**Pacific Gas and  
Electric Company**

PG&E Letter DCL-03-121

Docket No. 50-323, OL-DPR-82  
Diablo Canyon Unit 2  
PG&E Response to NRC Questions on 2R11 Steam Generator Tube Inspections

**PG&E Response to NRC Questions on Unit 2 Eleventh Refueling Outage  
Steam Generator Tube Inspection 90-Day Report**

**Figure 11-1**

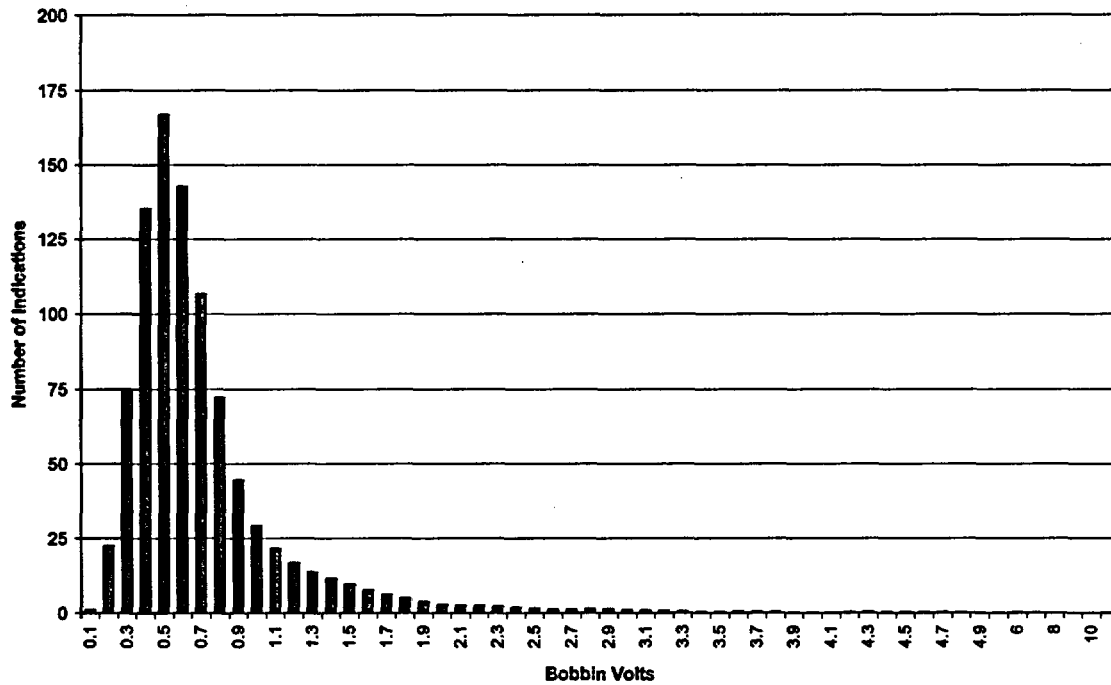
NRC Question 11:

*"Provide the EOC-12 Projections and POB and leak rate results of record for the method that PG&E has determined to be the most appropriate for predicting EOC-12 conditions."*

Table 11-5 provides the EOC-12 projected distributions that will be assessed against the as-found conditions at EOC-12. Figures 11-1 through 11-4 provide the EOC-12 distributions graphically.
